Product Change Notification

102760 - 00

**TXN1320, TXN1330 and TRN4035
family of Transponders, PCN102760-00,
FYI, Shipping Package Change.**

Figure 1: Old Package design – plastic insert

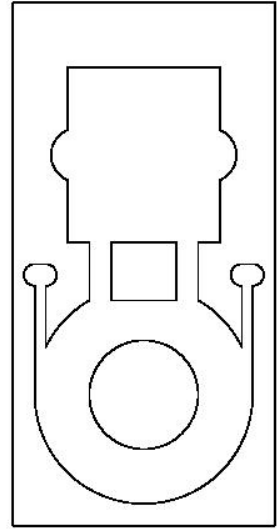
The shipping package for individual transponders will be changed from:

OLD: 14.5" x 8" x 1.7" conductive corrugated box, with plastic insert and cover, and tape to secure fiber spool

To:

NEW: 12.25" x 6.25" x 1.75" conductive corrugated box, with anti-static Polyam Polyethylene foam insert and cover, and foam fiber spool protective ring.
